NEW RESIDENCE FOR  
JEAN A COUTINHO

**APPLICANT:** Jean A. Coutinho **PETITION NO.:** V-8  
**PHONE:** 404-566-0177 **DATE OF HEARING:** 02/08/12  
**REPRESENTATIVE:** Michael P. Landry **PRESENT ZONING:** R-20  
**PHONE:** 770-425-1465  
**TITLEHOLDER:** Jean A Coutinho **LAND LOT(S):** 689  
**PROPERTY LOCATION:** On the south side of **DISTRICT:** 17  
Fairmont Road, south of Kenwood Road **SIZE OF TRACT:** 0.31 acre  
(5077 Fairmont Road). **COMMISSION DISTRICT:** 2  
**TYPE OF VARIANCE:** Waive the rear setback from the required 35 feet to 20 feet.

# V-8

# Application for Variance Cobb County

1 PROPOSED NEW SITE PLAN

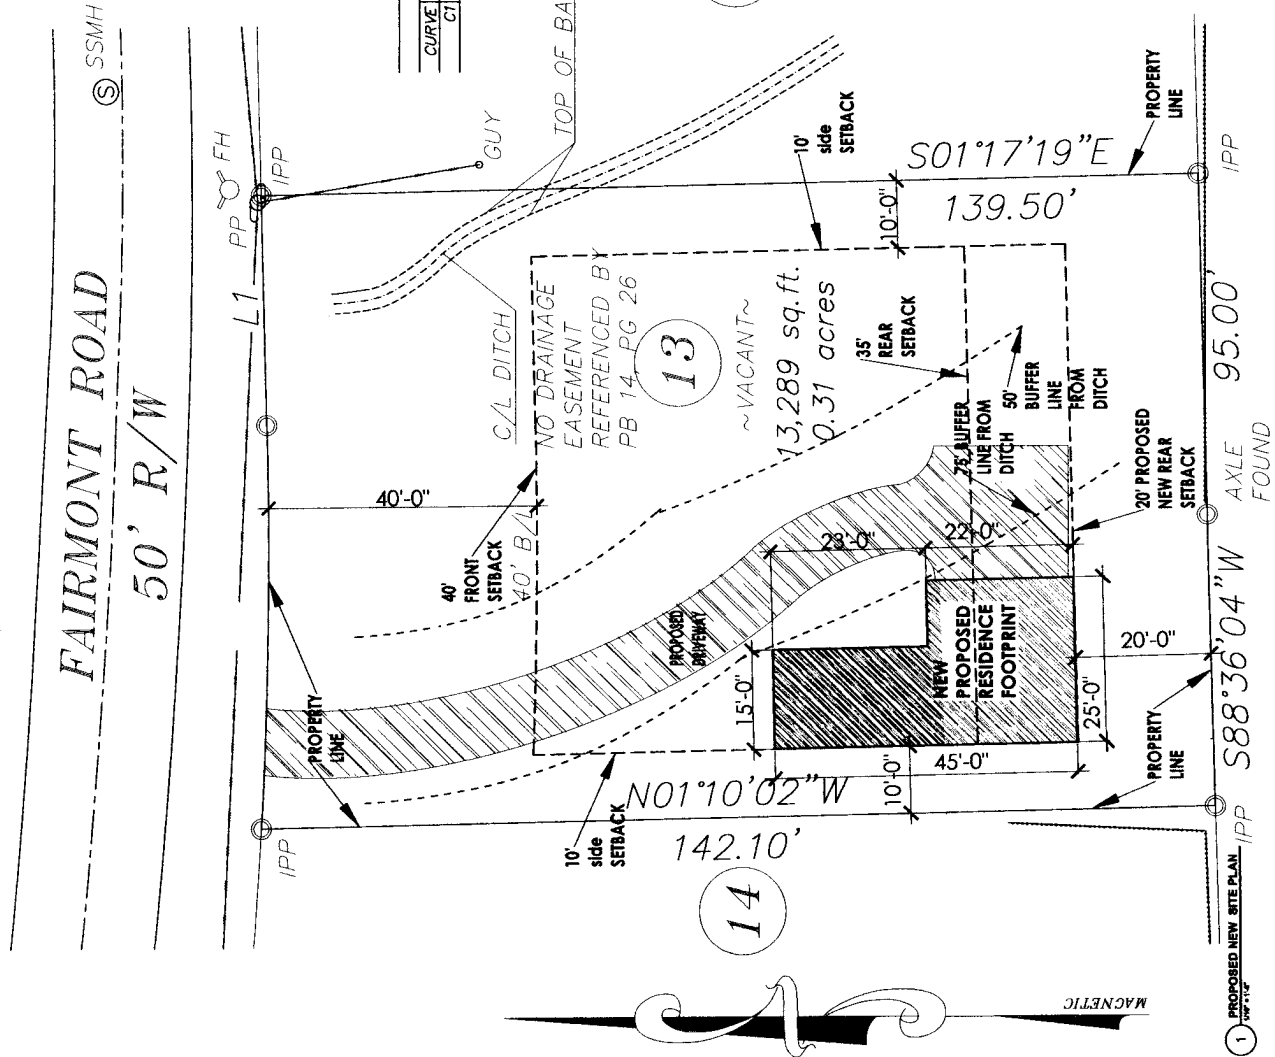
**SITE PLAN REVIEW:** If this variance request is approved, a subdivision plat revision must be recorded prior to the issuance of the certificate of occupancy showing all improvements on the lot and referencing the variance case in the standard plat revision note. The surveyor must submit the plat to the Site Plan Review Section, Community Development Agency for review and approval prior to recording. Call 770-528-2147.

**STORMWATER MANAGEMENT:** This is a currently vacant platted lot in an older subdivision (platted in 1955). The County's stream buffer ordinance creates a hardship for development of this lot to meet both the rear setback and the undisturbed buffer requirements. A separate variance from Community Development will also be required to allow the driveway encroachment into the impervious setback.
